# Access Compliance Report

## Public Rights-of-Way

Intersection ID: 14014	Main Street: N_SHARON_AMITY_RD	Cross Street: WILORA_LAKE_RD	Location: SW
ADA ID: 77FE65C65438	Ramp Type: Perp	Initial Pass/Fail: Fail	Overall Compliance: No
			Severity Score: 21.25

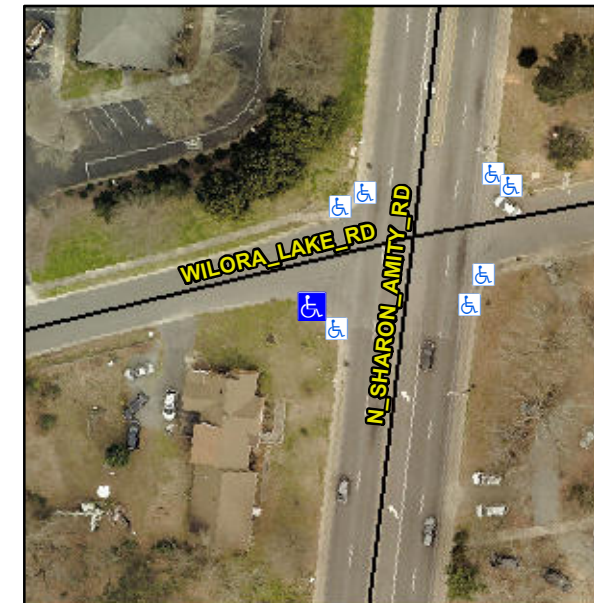
**Not Found, R304.5.1, R304.2.2**

Compliance	Description	Data	Compliance	Description	Data
N/A	Ramp Length (in)	57.5	No	Ramp Slope (%)	10.5
No	Ramp Width (in)	38.0	Yes	Ramp XSlope (%)	0.5
N/A	Flare Type LT	N/A	N/A	Flare Type RT	N/A
N/A	Flare Slope LT (%)	N/A	N/A	Flare Slope RT (%)	N/A
N/A	Flare Traversable LT?	N/A	N/A	Flare Traversable RT?	N/A
N/A	Landing Length (in)	N/A	N/A	DWS Provided?	N/A
N/A	Landing Width (in)	N/A	N/A	DWS Contrast?	N/A
N/A	Landing Slope (%)	N/A	N/A	DWS Length (in)	N/A
N/A	Landing X Slope (%)	N/A	N/A	DWS Full Width?	N/A
N/A	Landing Curb? (Y/N)	N/A	N/A	DWS Offset (in)	N/A
N/A	Shared Landing?	N/A			
N/A	Gutter Ponding?	Yes	N/A	Gutter Slope (%)	N/A
N/A	Gutter Lip Ht (in)	N/A	N/A	Gutter X Slope (%)	N/A
N/A	Painted X Walk1?	No	N/A	Painted X Walk2?	N/A
	X Walk 1 Direction	To NE		X Walk 2 Direction	N/A
N/A	X Walk 1 Width (in)	N/A	N/A	X Walk 2 Width (in)	N/A
	X Walk 1 Slope (%)	2.3		X Walk 2 Slope (%)	N/A
	X Walk 1 X Slope (%)	1.3		X Walk 2 X Slope (%)	N/A

**Remove & Replace Entire Ramp.**
